DART SERVICE INSTRUCTION

TO AMEND INSTALLATION INSTRUCTIONS D206-540 REV. K OR LATER APPROVED REVISION

REF. TCCA STC: SH94-5

REF. FAA STC: SR00386NY

**FIGURE 1: OPTIONAL D206-540-013 INSTALLATION
FWD CROSSTUBE SHOWN
VIEW LOOKING AFT**

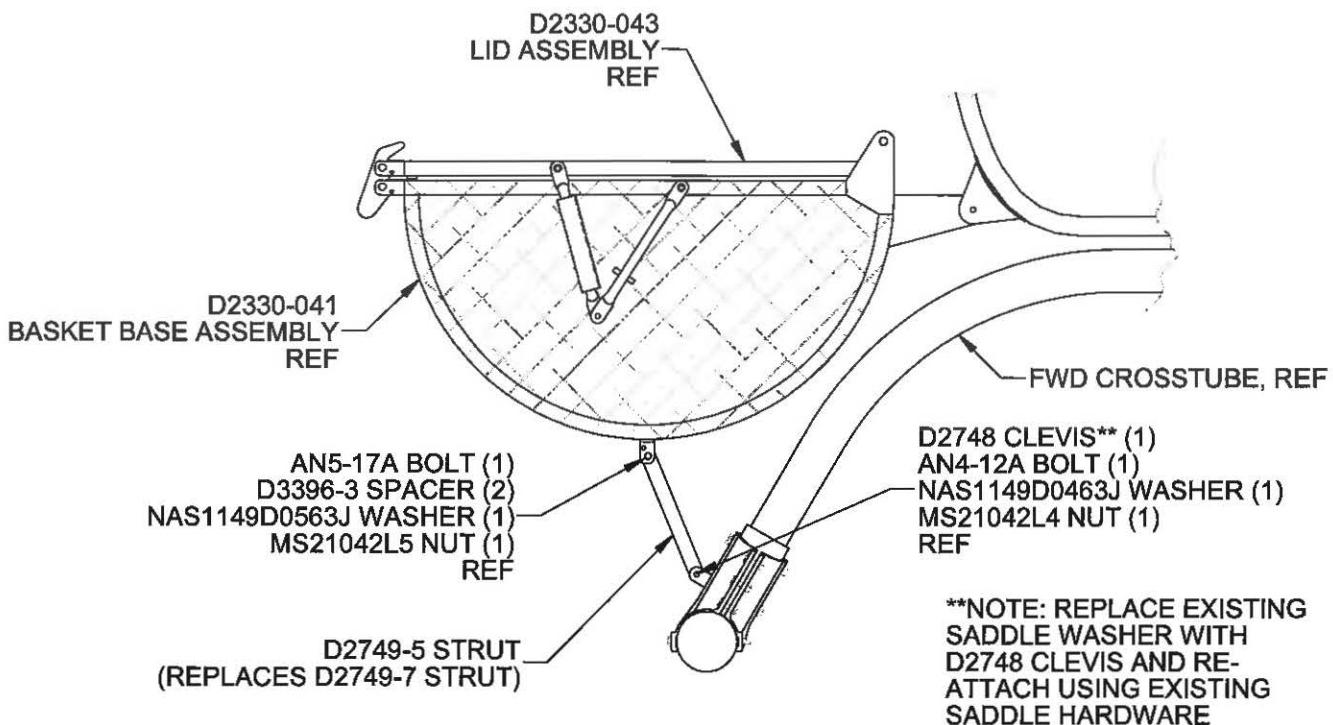
It has come to Dart's attention that the D206-540-013 Heli-Utility-Basket may not sit level on some aircraft. On affected D206-540-013 Heli-Utility Baskets, the D2749-5 Strut (available from Dart Aerospace) may be installed in lieu of the shorter D2749-7 Strut as shown below.

The Heli-Utility-Basket should otherwise be installed per Installation Instructions D206-540 and maintained per Maintenance Manual Supplement MMS-D206-540. This service instruction has negligible effect on Weight and Balance.
